International Aero Engines

SERVICE BULLETIN

ENGINE - L. P. COMPRESSOR - INTRODUCTION OF NEW HIGH TENSION BOLT FOR
NO.2 BEARING SUPPORT FLANGE

V2500-ENG-72-0350

Location of the bolts that connect the No.2 Bearing Support to the Fan Frame for V2500-A1 and V2500-A5
Figure 1

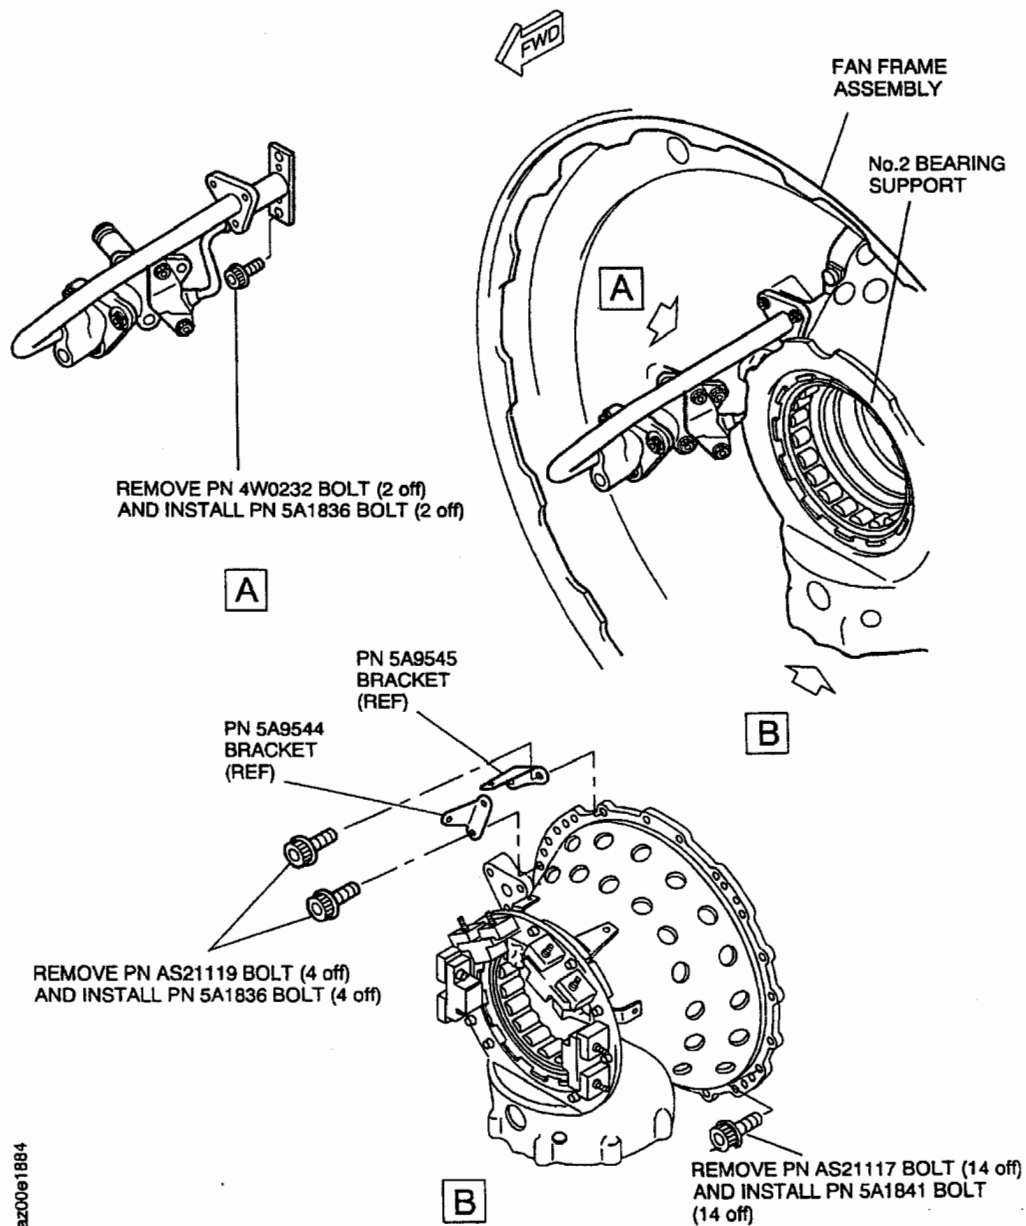
The material of bolts that connect the No.2 Bearing Support to the Fan Frame has been changed from steel to nickel alloy.

Install new 5A1836 bolt (6 off) and new 5A1841 bolt (14 off) to the No.2 Bearing Support Assembly by the procedure given in reference (1), Engine Manual (E-V2500-1IA), 72-30-00, Assembly-03 and Assembly-04.

Location of the bolts that connect the No.2 Bearing Support to the Fan Frame for V2500-D5

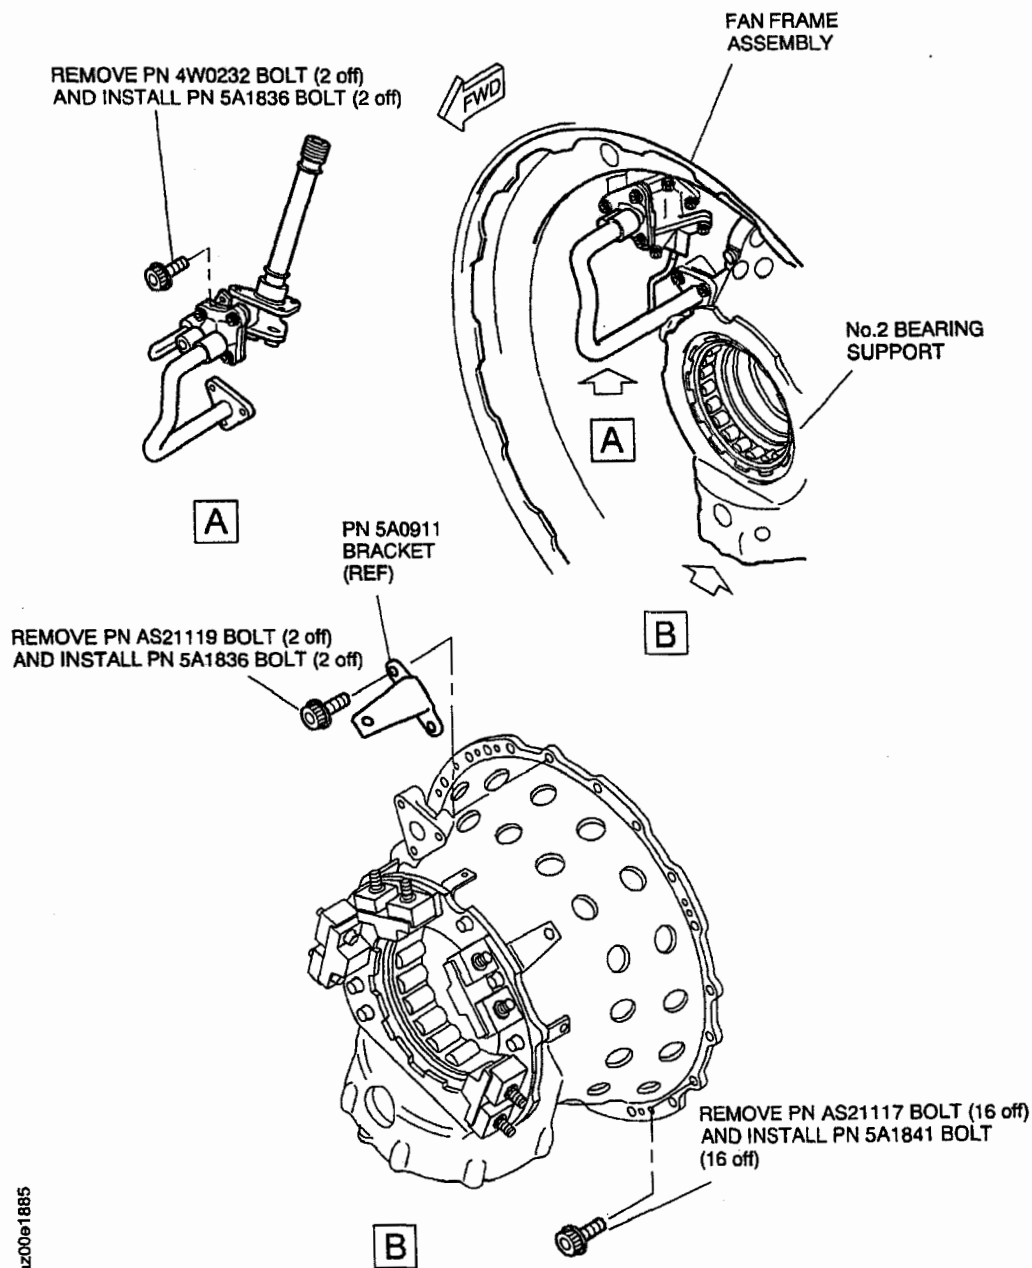
Install new 5A1836 bolt (4 off) and new 5A1841 bolt (16 off) to the No.2 Bearing Support Assembly by the procedure given in reference (2), Engine Manual (E-V2500-3IA), 72-30-00, Assembly-03 and Assembly-04.
